BOARD OF ZONING ADJUSTMENT

STAFF REPORT Date: July 10, 2017

CASE NUMBER 6121/6045

LOCATION 2704 Spring Hill Avenue

SITE PLAN

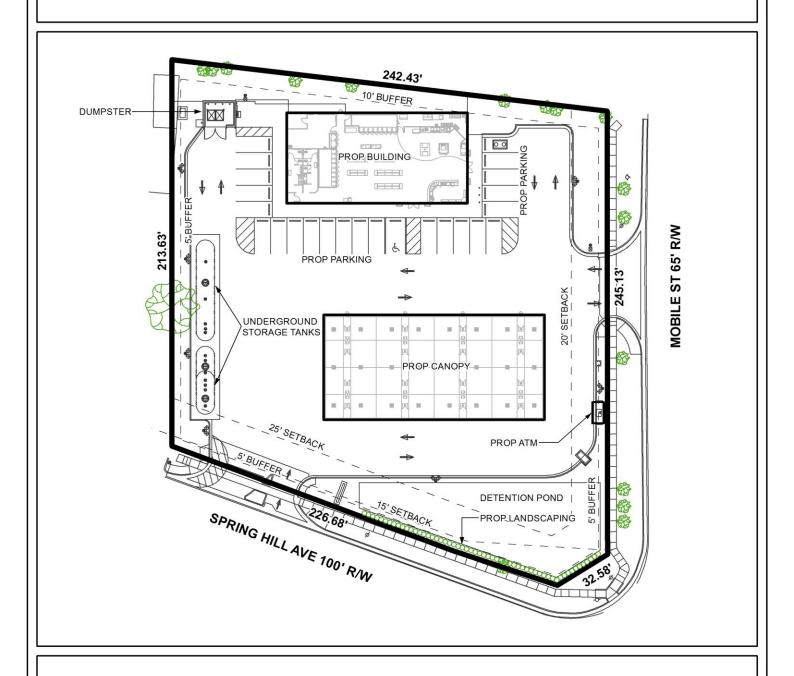
a. The proposed structure shall not disrupt any of the proposed drainage patterns or surface flow characteristics.

b. Applicant agrees to install adequate BMPs during construction to protect from sediment/pollutants leaving the site.

c. Show and label the additional structure on the As-Built plans.

Engineering Dept. recommends approval of this request so that the required landscape plantings will NOT be located within the detention pond area. If the Frontage Tree Variance is approved the applicant will need to have the following conditions met:

- a. Applicant agrees to install adequate BMPs during construction to protect from sediment/pollutants leaving the site.
- b. Show and label the additional plantings on the As-Built plans

The site plan submitted for land disturbance was originally approved with trees required along the Spring Hill Avenue frontage proposed within the Stormwater pond. The site plan was also approved without the proposed ATM with the understanding that a Setback Variance would be required to allow such. As designed, does not appear to be any location within the Spring Hill Avenue frontage area to accommodate the required frontage trees. And as the ATM is proposed to be positioned directly at the access/maneuvering area curbing, the possibility exists for collision with the ATM by maneuvering vehicles as well as the driver-side use of the ATM may create a contra-flow situation.

- 1) placement of bollards along the curbing edge to prevent vehicular collision with the ATM:
- 2) obtaining of permits for any signage on the ATM; and
- 3) full compliance with all other municipal codes and ordinances.

- 1) donation of six (6) trees to the Tree Bank; and
- 2) full compliance with all municipal codes and ordinances.
